DEVELOPMENT REVIEW BOARD  
SUPPLEMENTAL SUBMITTAL

PROJECT NO. PR-2019-002277  
Application No. SI-2019-00246

SUBMITTAL DESCRIPTION: DRB Site Plan Resubmittal.

**RE: Adagio Apartments  
PR-2019-002277**

PROJECT NAME: ADAGIO APARTMENTS  
SHEET TITLE: SITE PLAN  
DRB SITE PLAN  
SHEET NUMBER: C-100

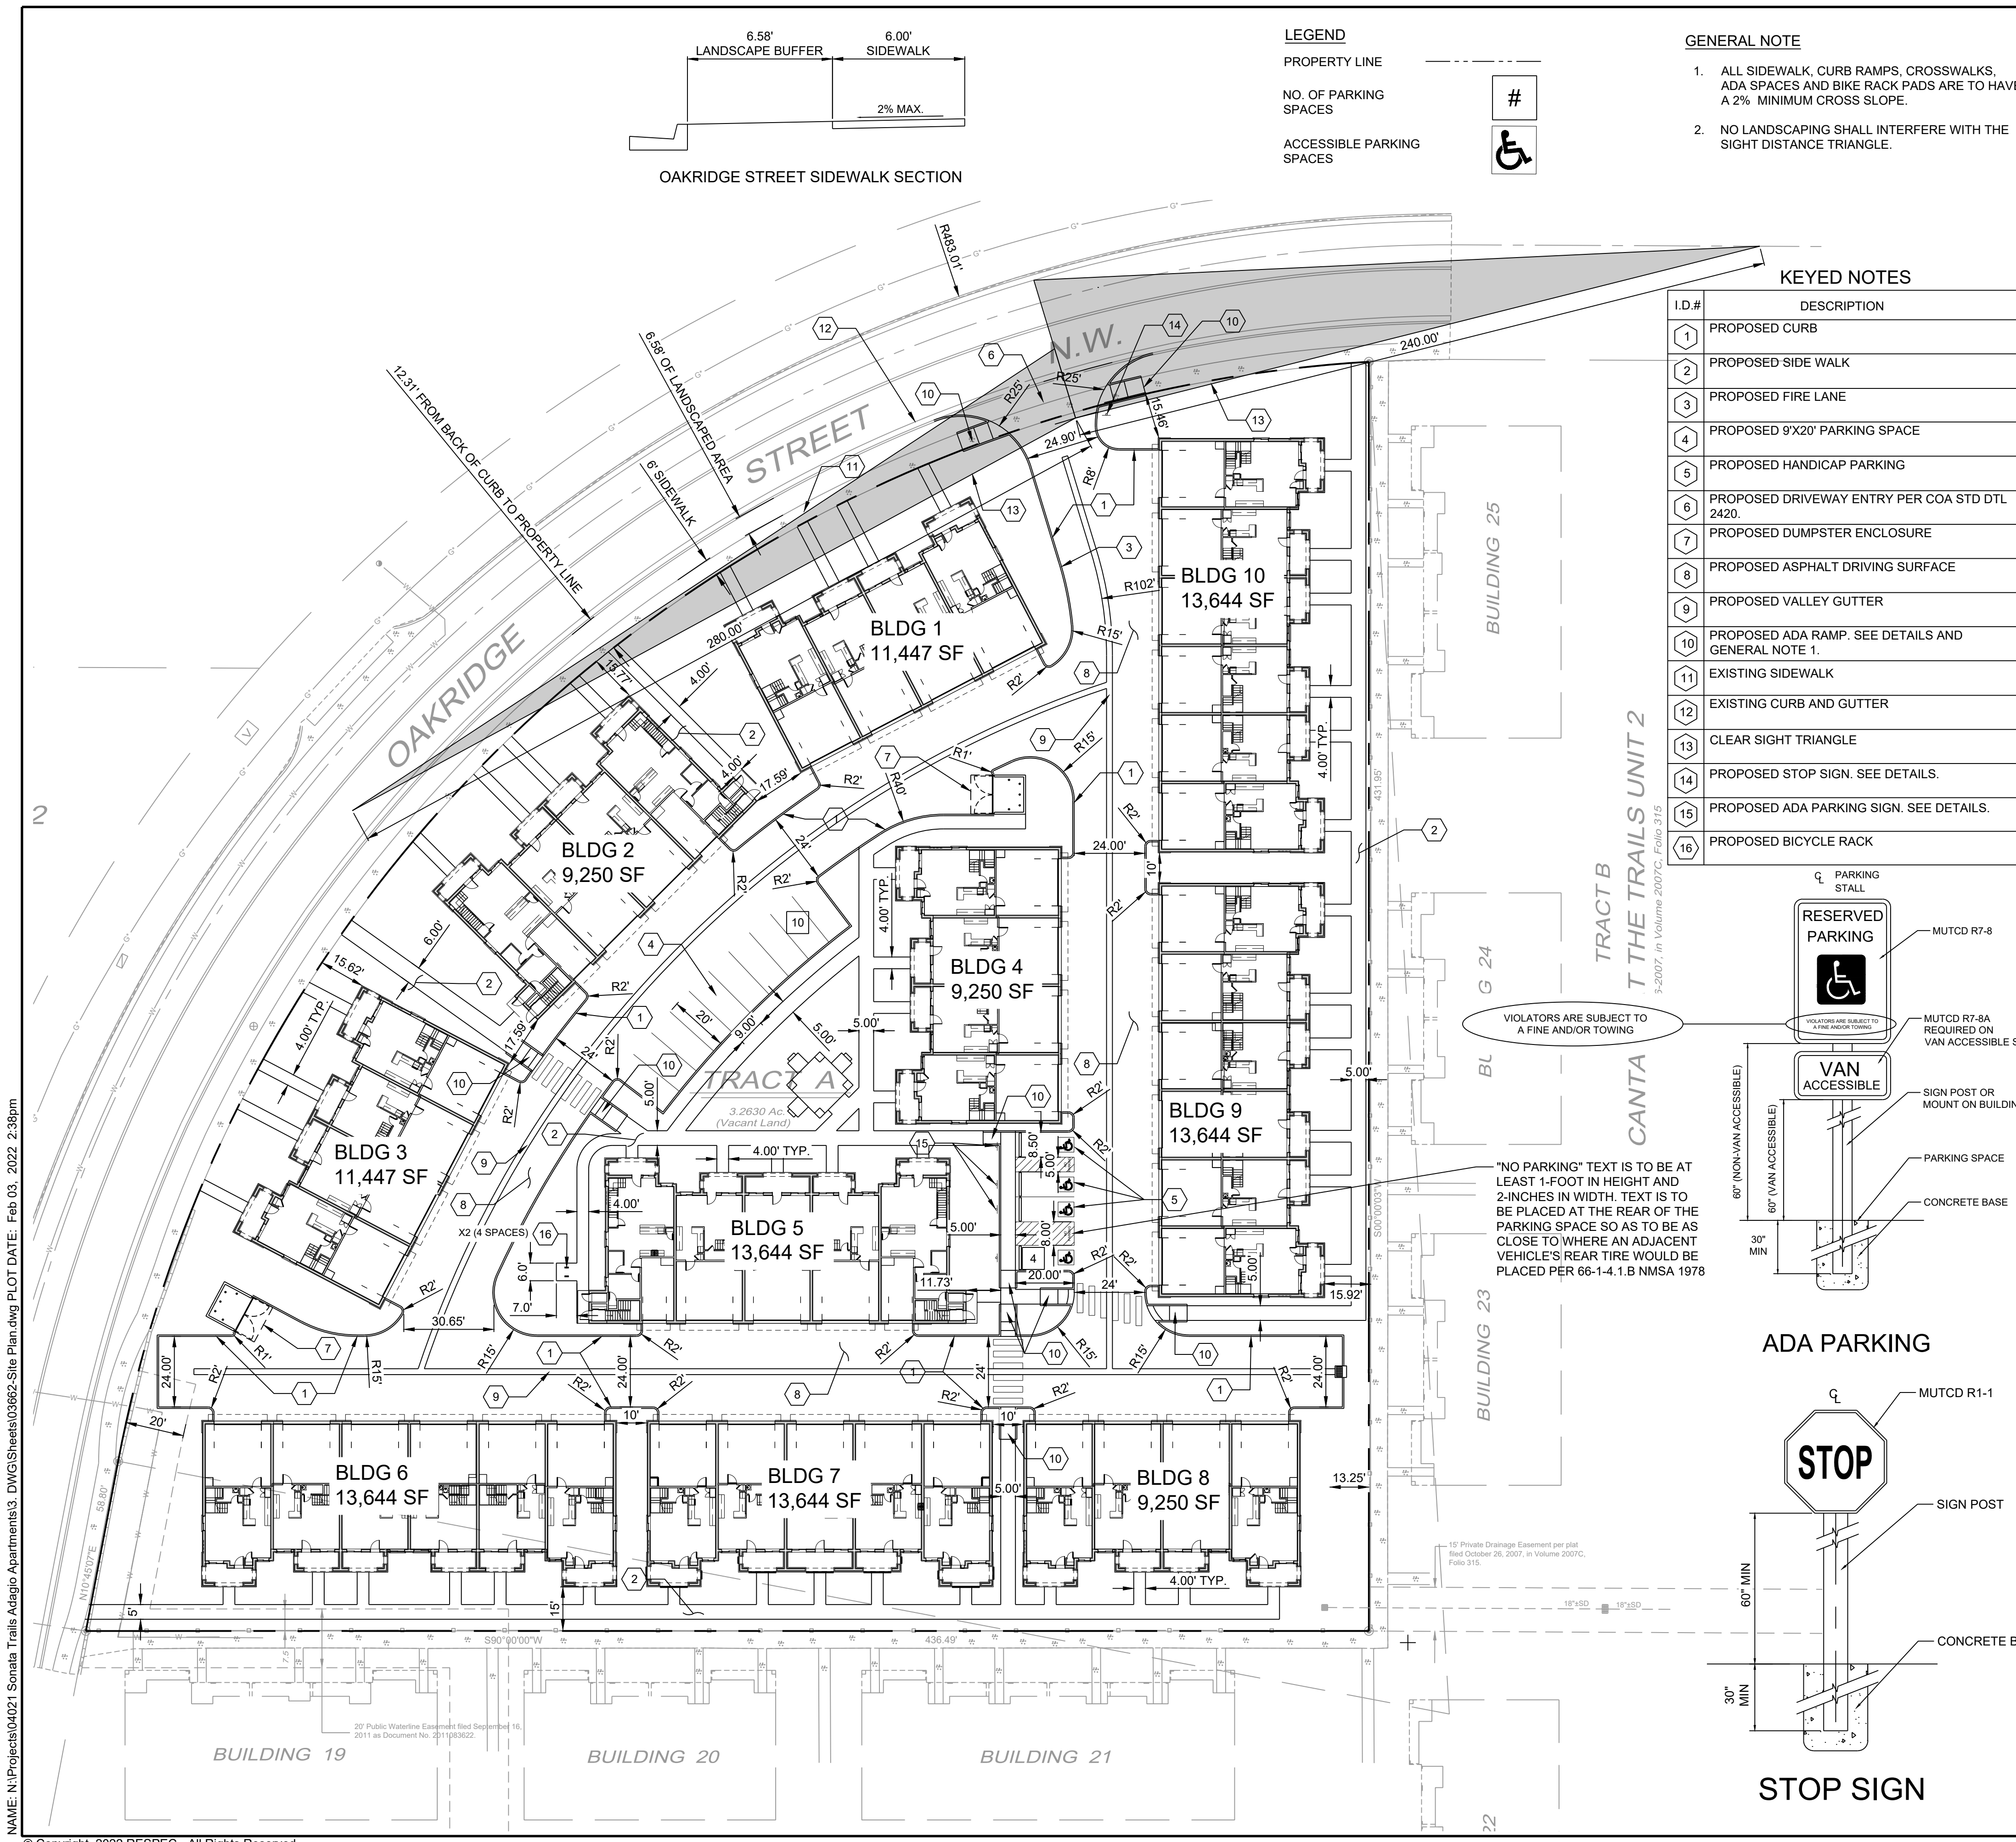
- / Have the number of bicycle racks match bicycle space requirements and dimension the bicycle rack space (Keyed Note 16).
  - o *Response: The number of bicycle racks and dimension has been added to the revised site plan sheet attached.*
